SERVICE BULLETIN

MODEL NAME : Di620
MODEL CODE : 1155
NO. : 040L
DATE : 990830
SUBJECT : SOFTWARE PROGRAM OF IC26IB ON PWB-IB CHANGE

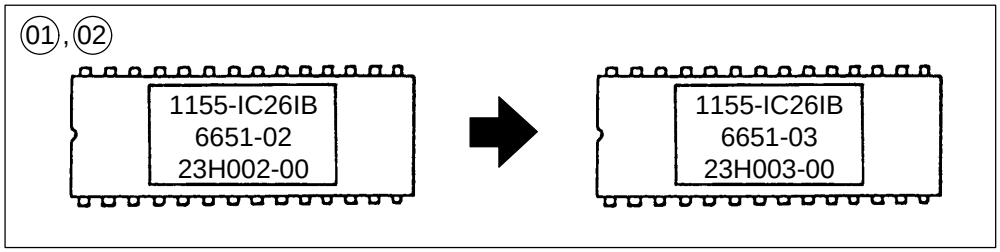
The software program of IC26IB (01, 02) on P. W. Board-IB has been changed to make the following specification change.

When documents are loaded over capacity (100 sheets) on the document feed tray:

Before Modification

C143E (Problem with EDH Pick-Up Motor) is detected.

After Modification

EDH Misfeed at Take-Up section is detected.
